SCALE: 1" = 100'  
PROPOSED SUBDIVISION PLAN

**CENTURY LEASING CORP.**  
214 PLAISTOW ROAD  
PLAISTOW, NH

PREPARED FOR:  
**MICHAEL PANIELLO**  
214 PLAISTOW ROAD  
PLAISTOWN, NH 03865

SCALE: 1" = 100'	CALC. BY: B.R.D.
DATE: 11/22/2020	CHKD. BY: S.L.C.
PROJ: ALP-2005	SHEET 3 OF 5

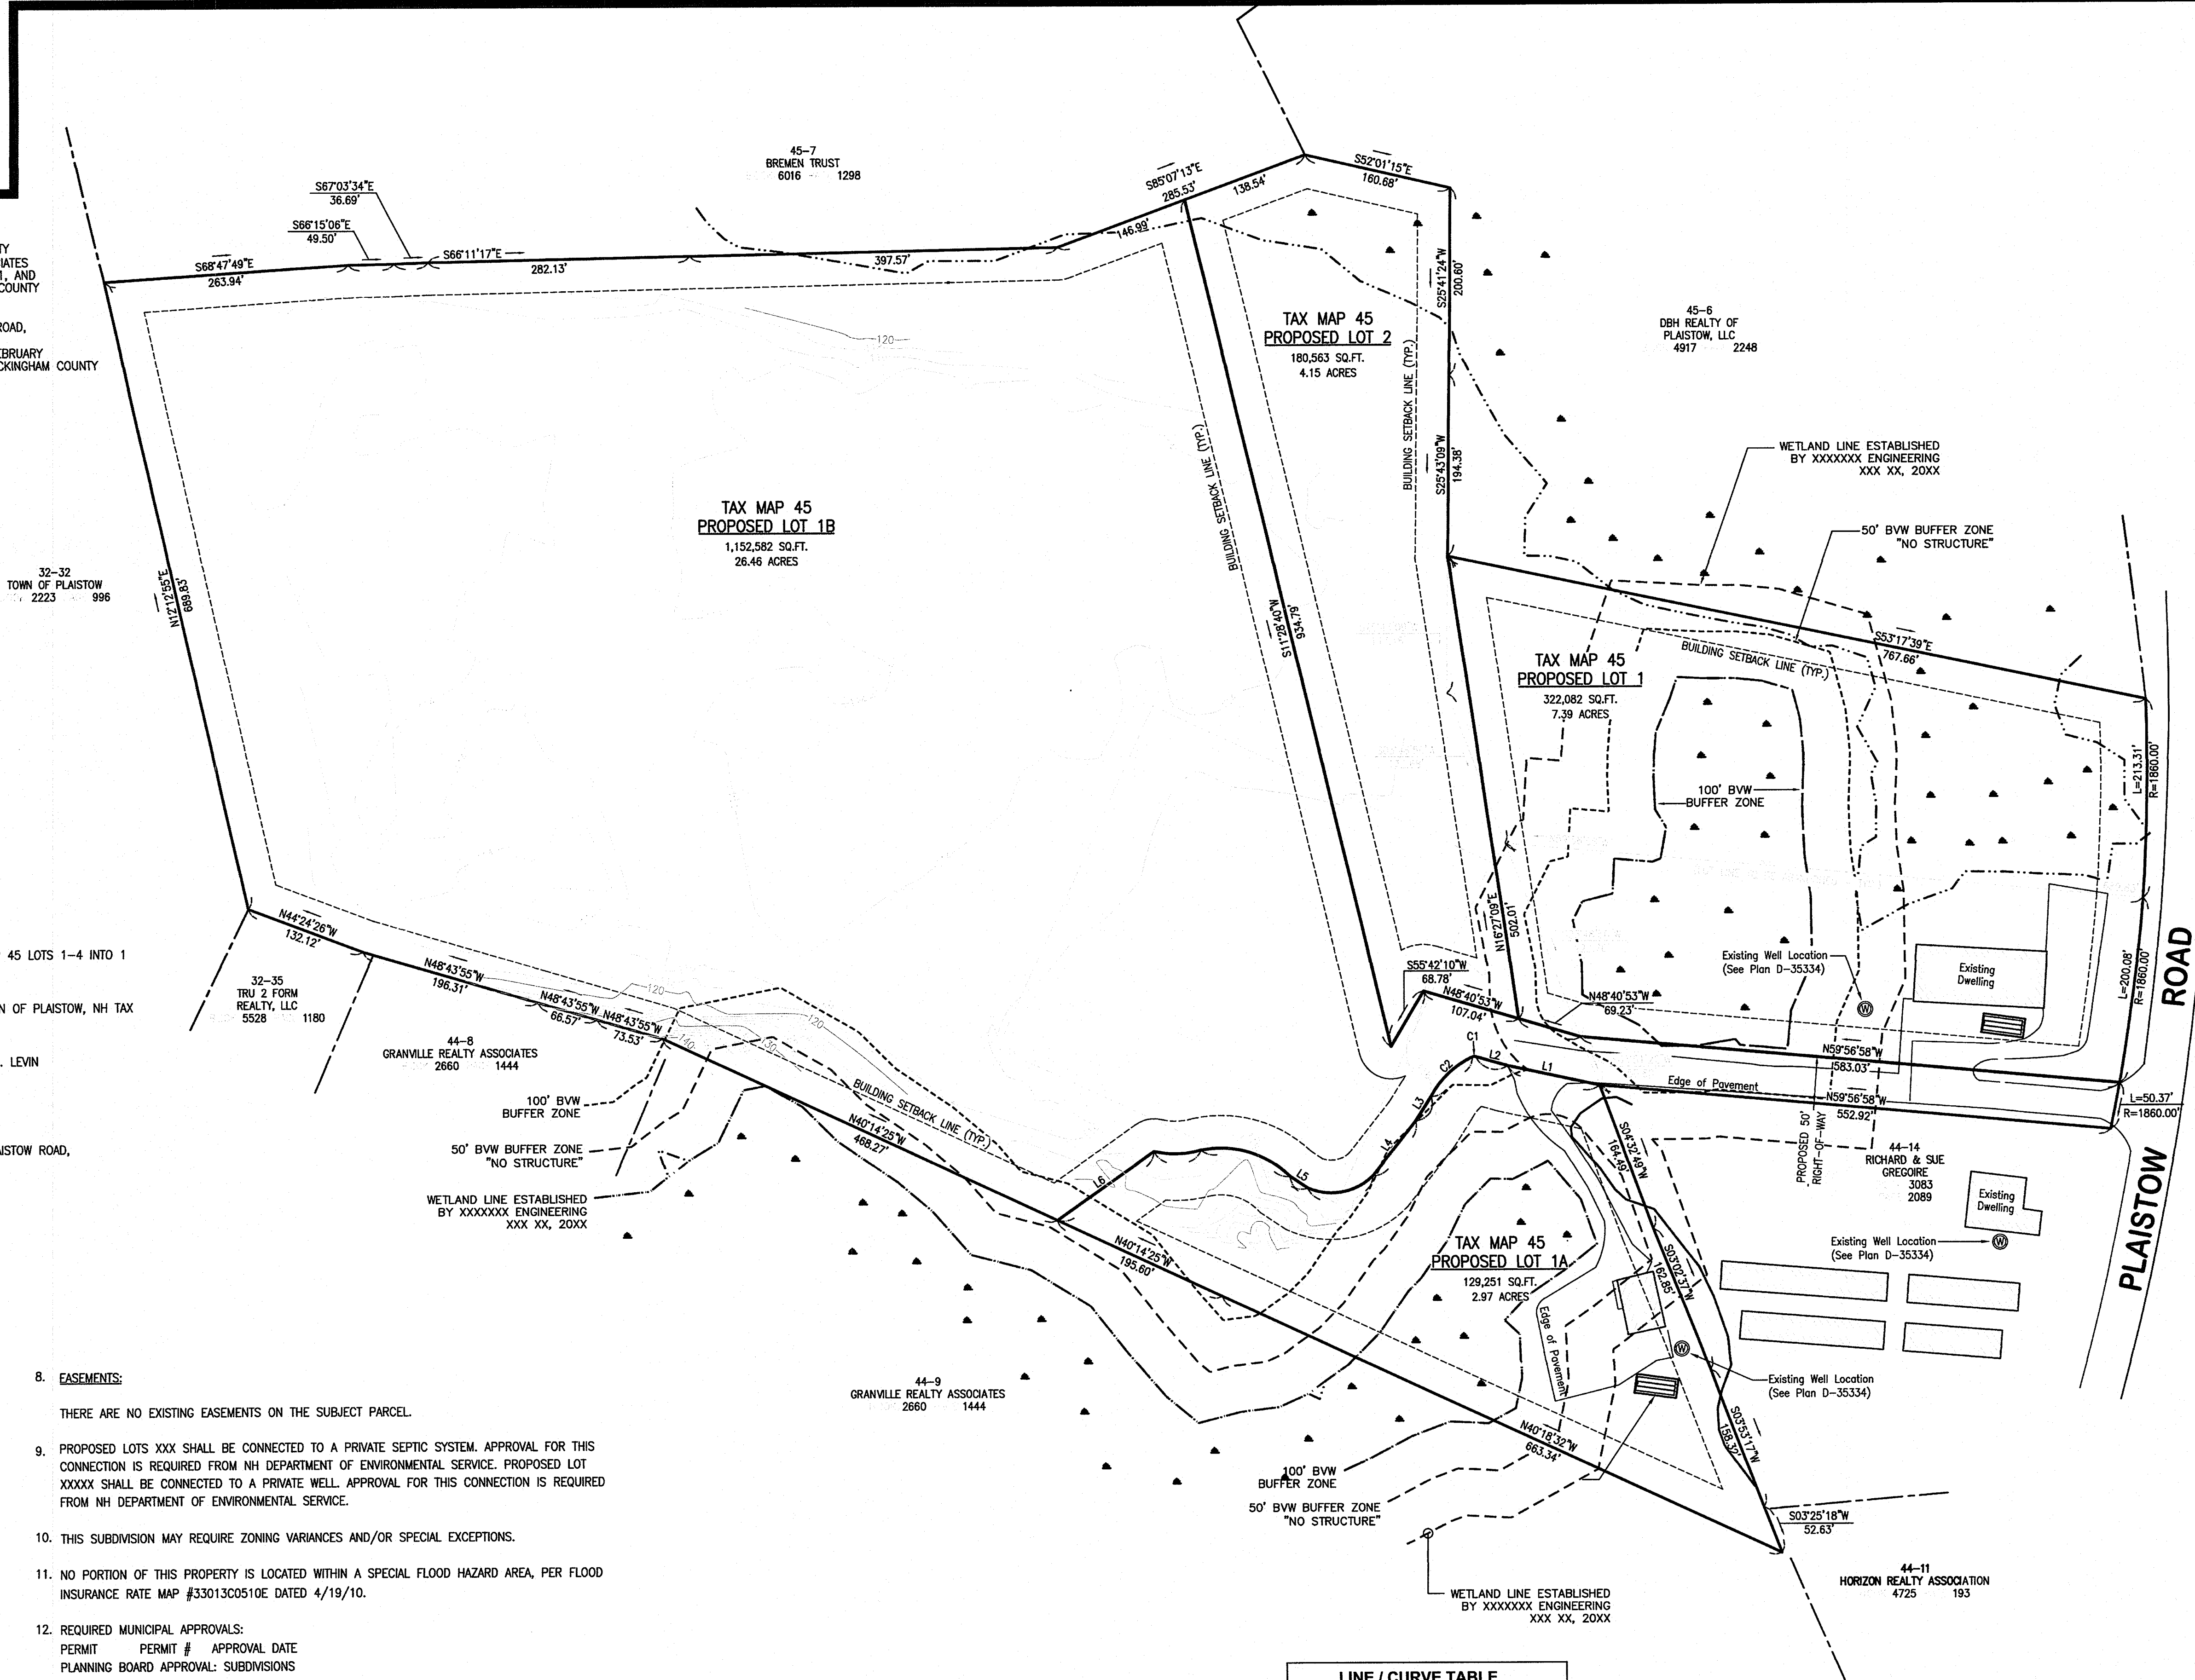
Look Like  
all The  
Same  
Copies.  
300 58 ft  
12/22
